## S. Syene Advisory Group Meeting #4 Notes

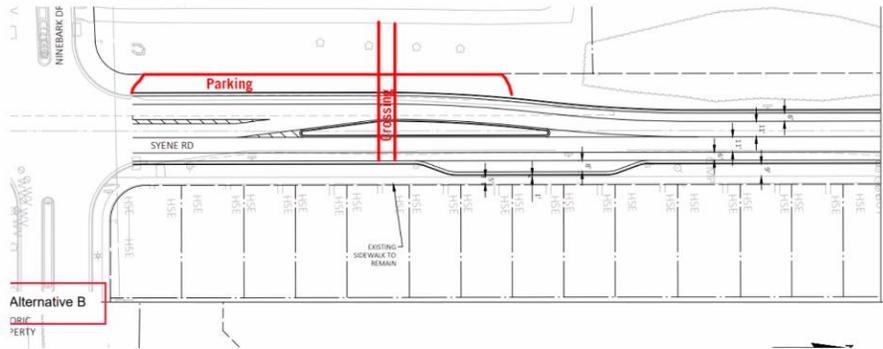
- Across from Syene we could potentially have parking like the picture above
- Ron G - Not in favor of putting parking on the West side of Syene... would cause much more trouble than good (regarding safety, weather, etc.)
